### MEMORANDUM

To: Development Review Board  
From: Mary O'Neil, AICP, Principal Planner  
Date: June 6, 2023  
RE: ZP-23-164; 75 Cherry Street

**Request:** Amendment to existing permit for changes within discretionary height area, including additional dwelling units and exterior building changes.

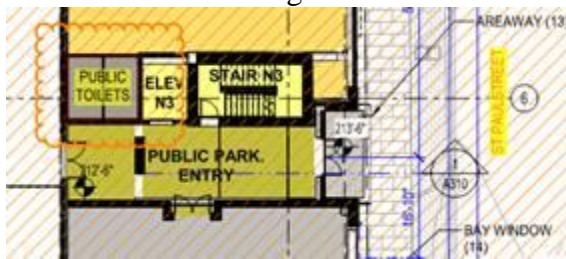
There is 129,855 sq. ft. on floor levels more than 85' above grade, requiring 2,597 sq. ft. of accessible roof terrace, 260 square feet of public restroom space, or some combination of the two. With the rooftop restaurant no longer in the program, insurance challenges and no way to

supervise rooftop access, the compliance path will be publicly accessible ground level restrooms to be accessed via Pine, Bank, or St. Paul Street.

The locations have been identified and are in future phases of construction, all are at the ground level and total slightly more than the 260 sq. ft. required based on 129,000sf of floor area on levels >85 feet above grade:

7. In lieu of upper story rooftops or terraces accessible to the public, the applicant shall provide a minimum of 260 sq. ft. of public restroom(s). Public restrooms must be located on the ground floor, have a minimum size of 50 sq. ft., be signed from the public street, be actively monitored and maintained, and be open to the public during all regular business hours.
